WYNNFIELD SUBDIVISION, RESUBDIVISION OF LOT 40, UNIT TWO, AND LOT 51, UNIT THREE

APPLICATION NUMBER 23 DATE September 4, 2003

REQUEST Subdivision

WYNNFIELD SUBDIVISION, RESUBDIVISION OF LOT 40, UNIT TWO, AND LOT 51, UNIT THREE

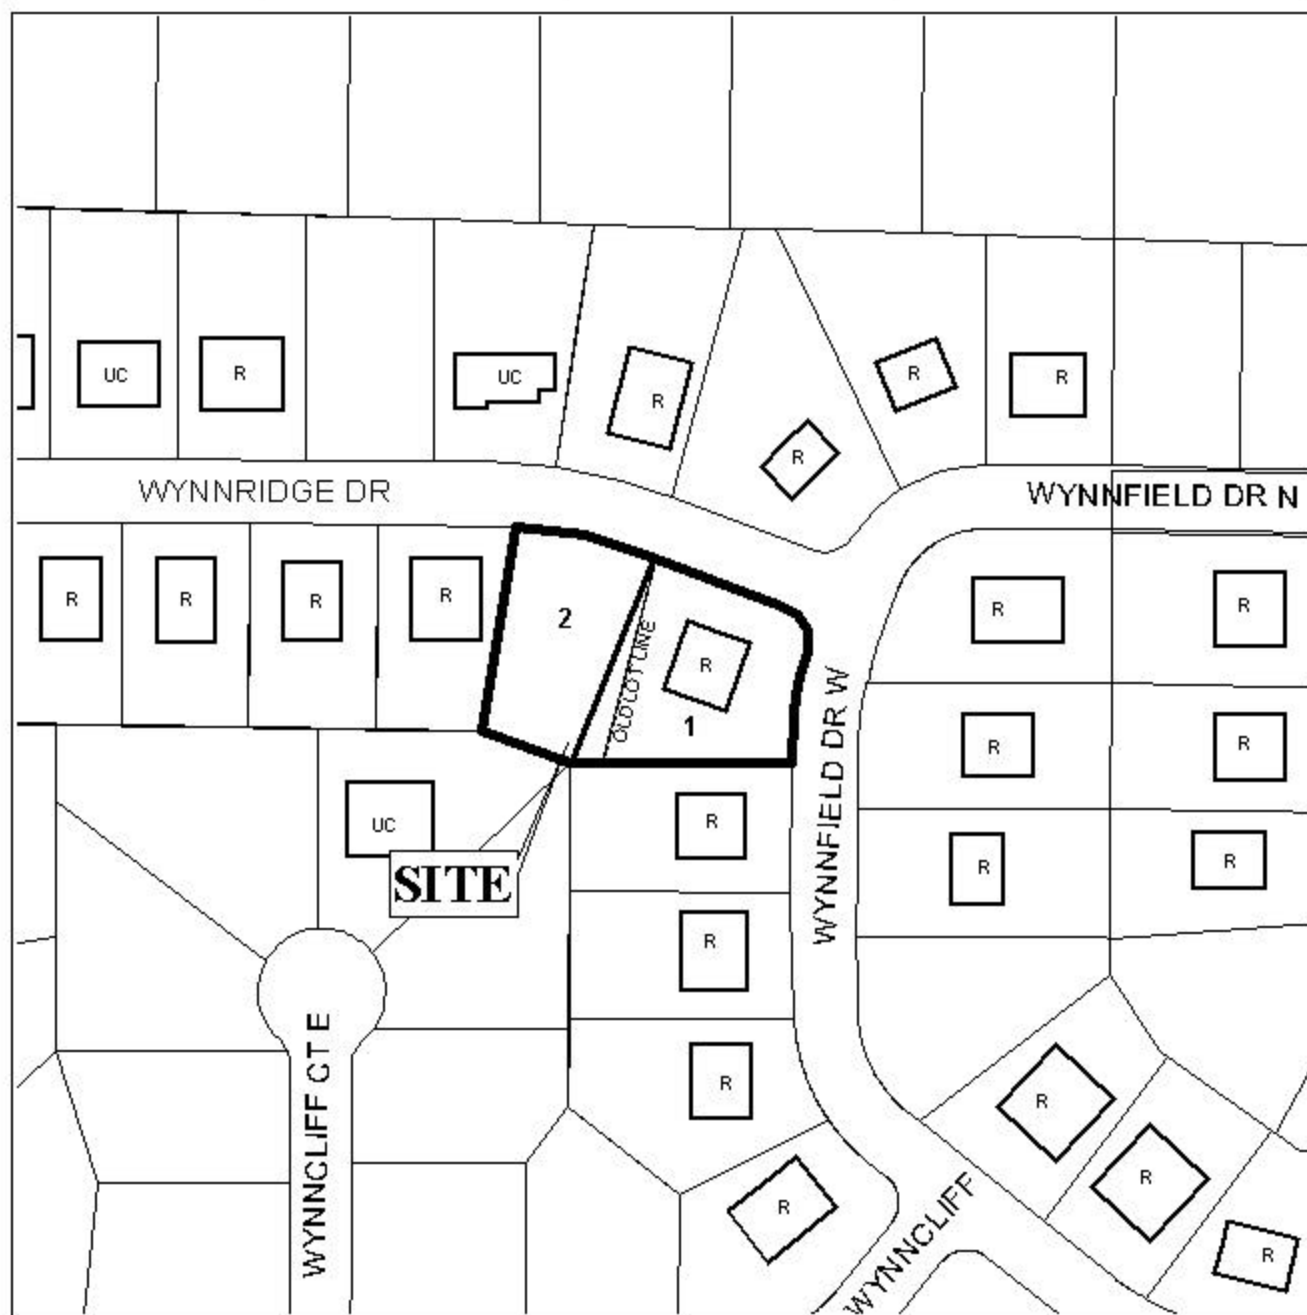
The plat illustrates the proposed 2-lot, 0.9± acre subdivision which is located on the Southwest corner of Wynnfield Drive West and Wynnridge Drive. The site is served by city water and sanitary facilities.

The purpose of this application is to shift an interior lot line between two adjacent legal lots of record.

The plat meets the minimum requirements of the Subdivision Regulations and is recommended for Tentative Approval.
